AGENDA ITEM #3

17-SC-13 – 1289 Eureka Avenue

Approve design review application 17-SC-13 subject to the listed findings and conditions

Photo #1:

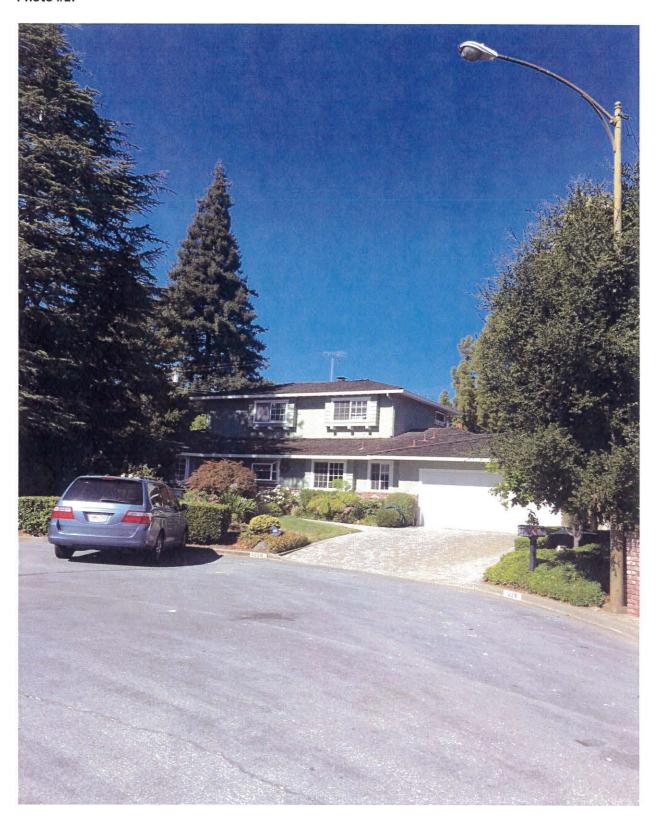
- 1. The applicant's definition of 'the neighborhood', while perhaps technically correct, is not an accurate representation of 'the neighborhood'.
 - a. The applicant lists homes across Grant Rd. to be 'in the neighborhood', which they are not.
